Re: Product Change Notice

Product Change Notice for CONSMA007-R178 and CONREVSMA007-R178

PCN #: LPCN-130618

Manufacturing change for CONSMA007-R178 and CONREVSMA007-R178

Figure 1: CONSMA007-R178 spacer and support lengths

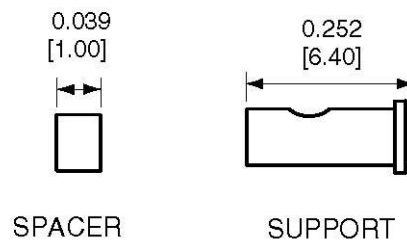
The products are mechanically similar to, and offer enhanced electrical performances to, the previous versions of the products. The manufacturing change made to the CONSMA007-R178 is the use of a thinner spacer and the use of a longer support when connecting CONSMA007-R178 to a coaxial cable. The manufacturing change made to the CONREVSMA007-R178 is the use of a thicker spacer when connecting CONREVSMA007-R178 to a coaxial cable.

The adjusted spacer and support lengths for the CONSMA007-R178 connector are illustrated in Figure 1 below. The adjusted spacer length for the CONREVSMA007-R178 connector is illustrated in Figure 2 below.
